Residential and Tourist Development Subdivision
Lot 156 Creek Street Hastings Point
MP06_0154 – Environmental Assessment Exhibition

A Review

Henry James
Consultant Botanist and GIS Practitioner
Email: henryjames@wetnet.com.au

Figure 1

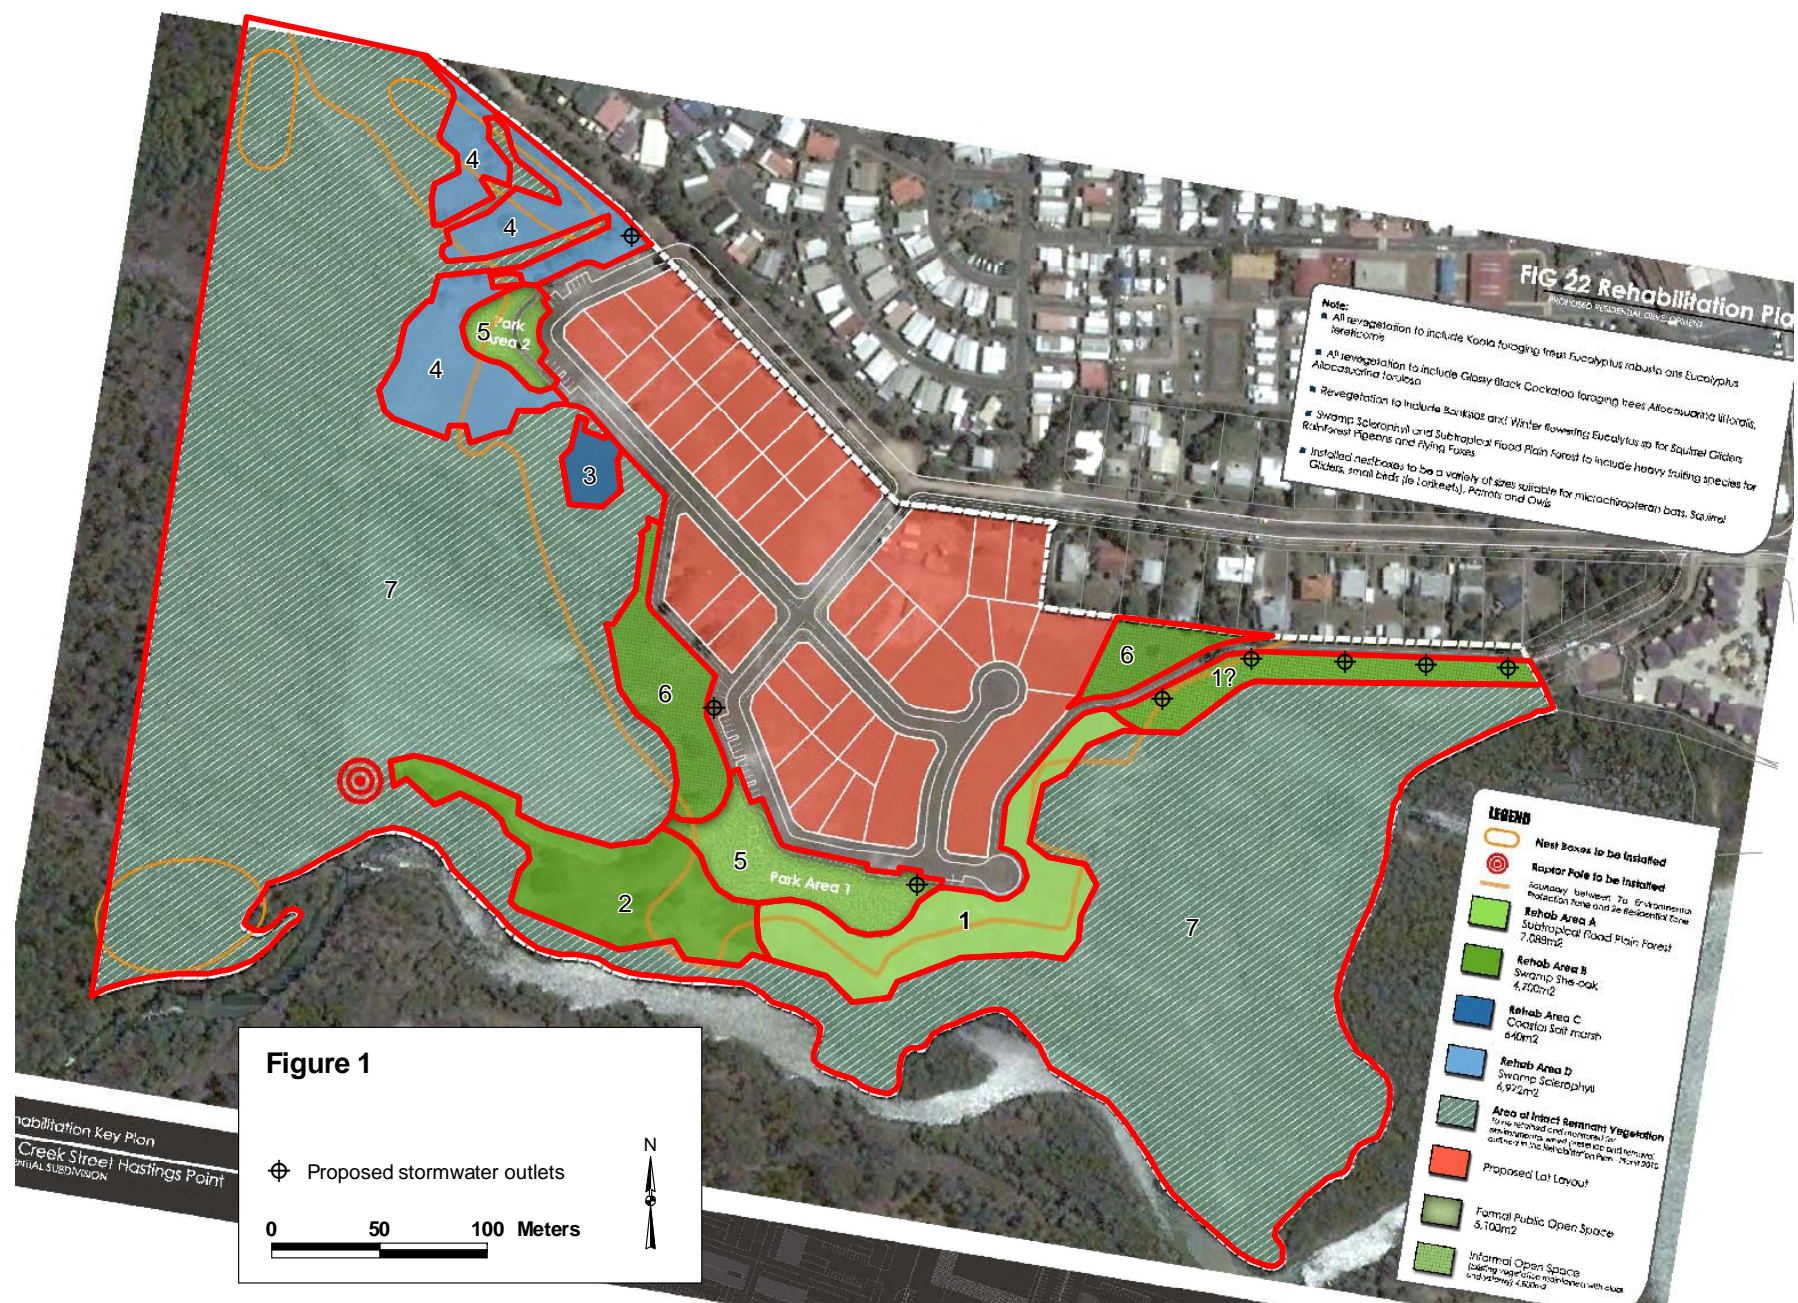
Notably, no GPTs are proposed for catchment C (the area of existing housing along Creek Street). The runoff from this area currently crosses 20 to 50 metres of grassland on the subject site before it reaches the wetlands to the south. The proposal is to eliminate this current infiltration path and pipe the runoff directly to the wetlands at five locations.

All proposed stormwater outlets are near areas of Coastal Saltmarsh (see figure 1 below). (Note, the EA does not identify Coastal Saltmarsh at the location of some of the proposed outlets, but this is yet another failure of the EA. (See a critique of this inadequacy elsewhere in this review.)

Even if the proposed filling of Coastal Saltmarsh is approved, the creation of 640 m² of Coastal Saltmarsh to compensate the direct loss falls well short of a number of relevant policies for compensation. (Note: the proposed area of replacement depicted

in the EA is actually nearer 798m² – see Table 1 below.) It is claimed in the EA that the loss would be 1740m², but it is more likely 2275m² in size (see above).

- In Figure 22 – Rehabilitation Plan, an area in the eastern part of the site south of the proposed flood access track is labeled “informal open space (existing vegetation maintained with clear understorey)”. In Figure 14 - Landuse Plan it is labeled “rehabilitated vegetation”, not “informal open space (existing vegetation maintained with clear understorey)”. The area in question is about 2,500 m² in size. See Figure 1 in this submission for a depiction of the location which is labeled “1?”. See also Table 1 below.
- There is a difference of 2992m² between the area claimed in Figure 22 for all types of dedication (apart from “area of intact remnant vegetation”) and area calculated using GIS.
- The figures for dedications in the executive summary do not add up (see Table 2 below). The error is 0.48 ha in size.
